To: Brad Johnson, WRIA 35 Planning Unit Mimi Wainwright, Washington State Department of Ecology	
From: John Koreny, HDR	Project: WRIA 35, Asotin and Alpowa Creek Hydrogeology Evaluation
CC: Kevin Lindsey, GSI Water Solutions, Inc. Ben Floyd, HDR	
Date: June 29, 2009	Job No:

RE: Response to Comments by Ecology on Draft “Asotin Creek and Alpowa Creek Hydrogeology Report” Dated May 8, 2009

Page 2.4, Section 2.4 Seepage Run

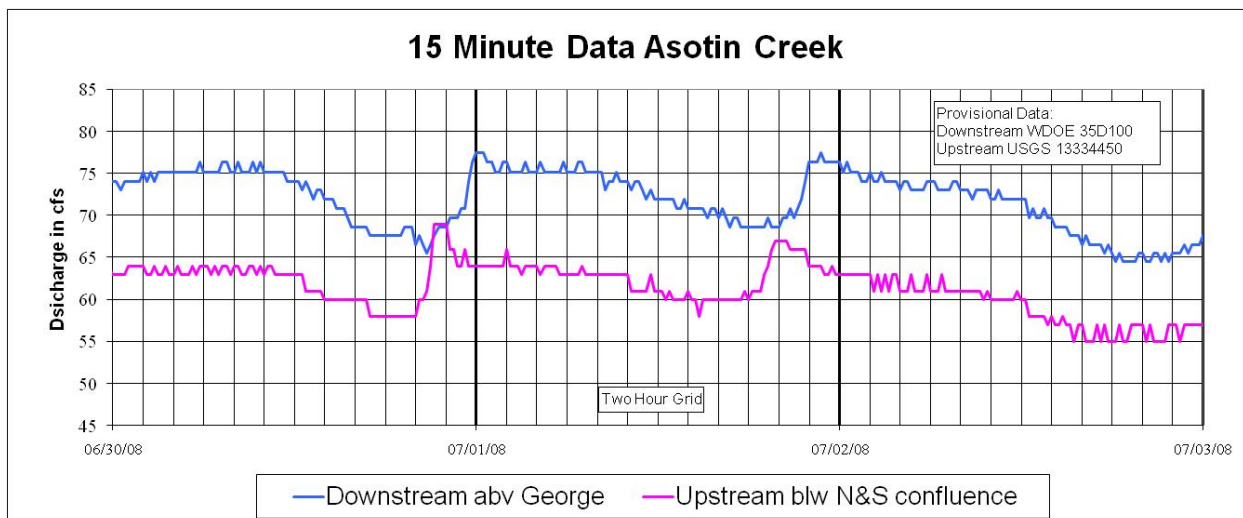
This section needs a new subsection that analyzes the available continuous flow gauge data. As discussed during our recent meeting, those data suggest significant diurnal fluctuations and this has direct bearing on the flow measurements made by HDR. For example, the data from two of the gauges are as follows:

As these data are for July when snowmelt is not a factor, they suggest diurnal changes due to ET losses from riparian vegetation. If HDR measured flow at sites successively lower within a system over the course of a day and ET losses increased over the same period, then gains in that particular stretch may be masked by the countering effects of these two variables. Analyzing continuous flow records and explaining what time of day particular measurements were made for the various stream reaches should shed light on this. Similarly the points on the graphs in figures 2-13, 2-15, 2-17 and 2-19 should list the time of day those measurements were taken.

See response to Comment 18.
